Figure 92-16 – ONU burst transmission termination

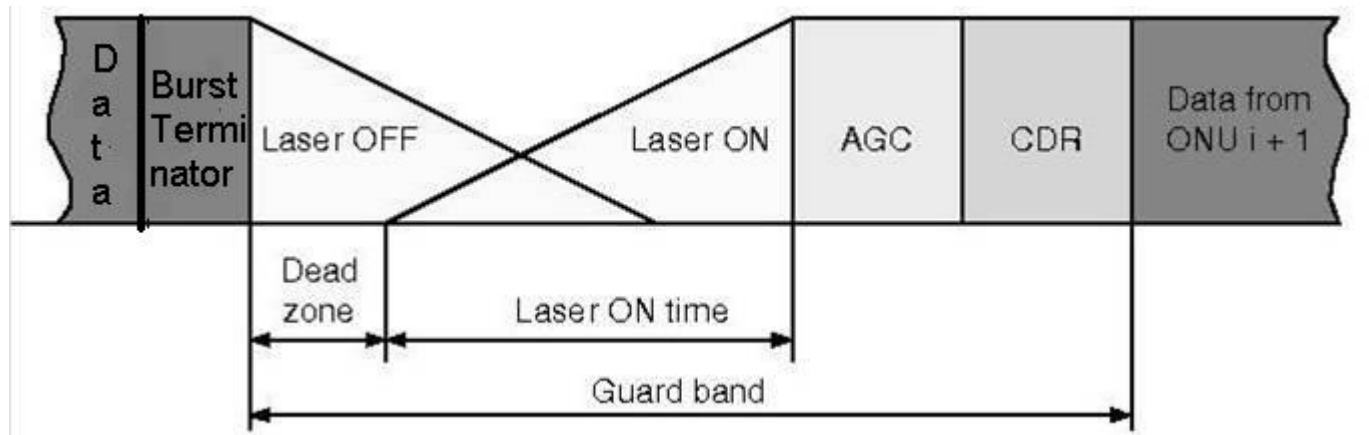
[Modify figure 92-16 thus:]

Figure 92-19– OLT Synchronizer state diagram

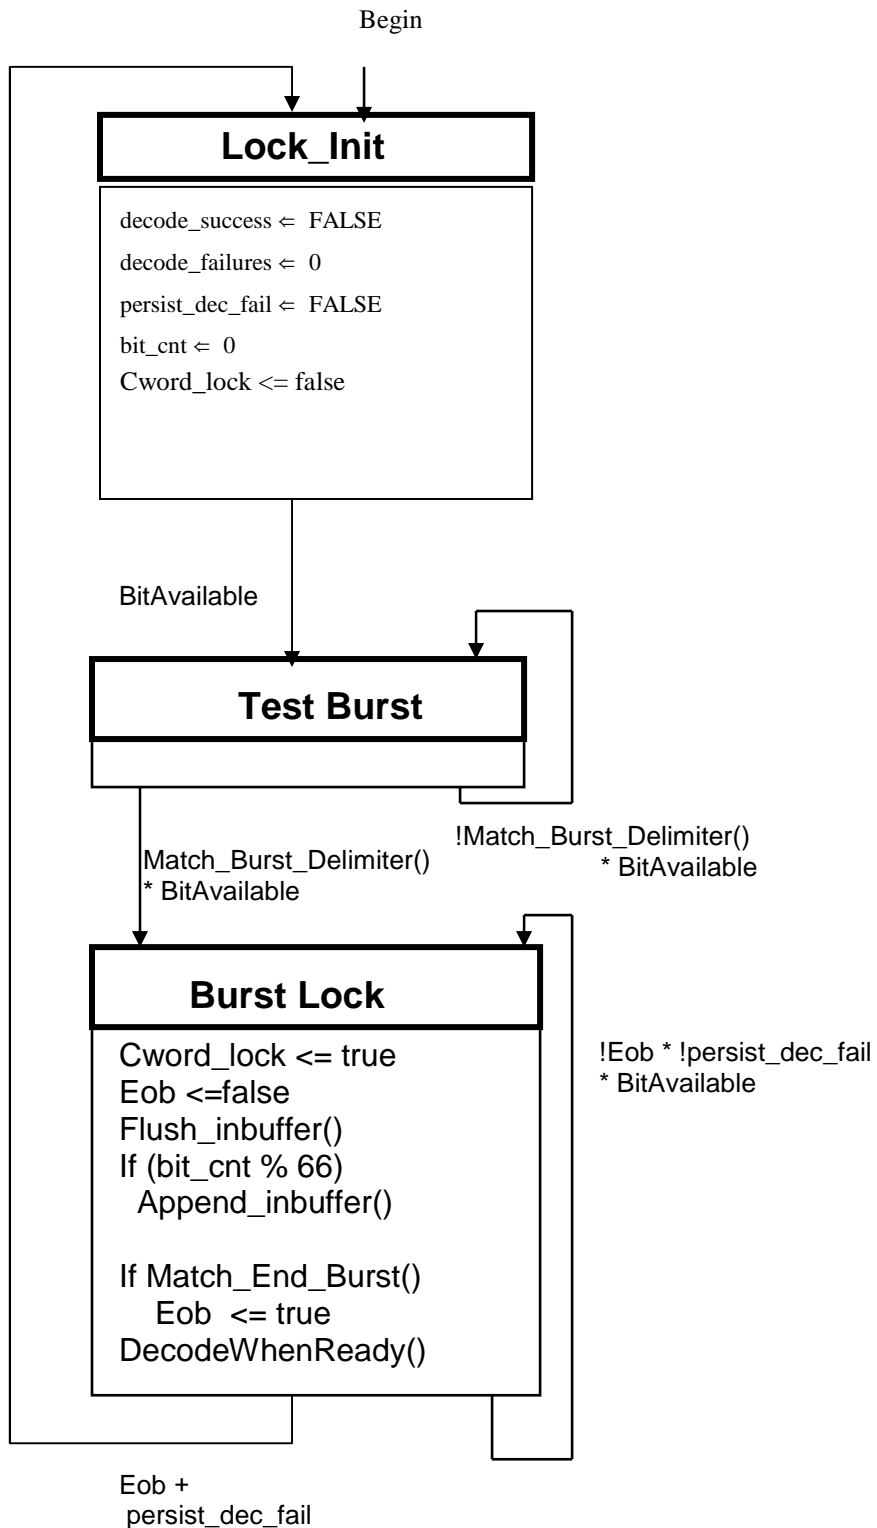
[Modify figure 92-19 thus:]
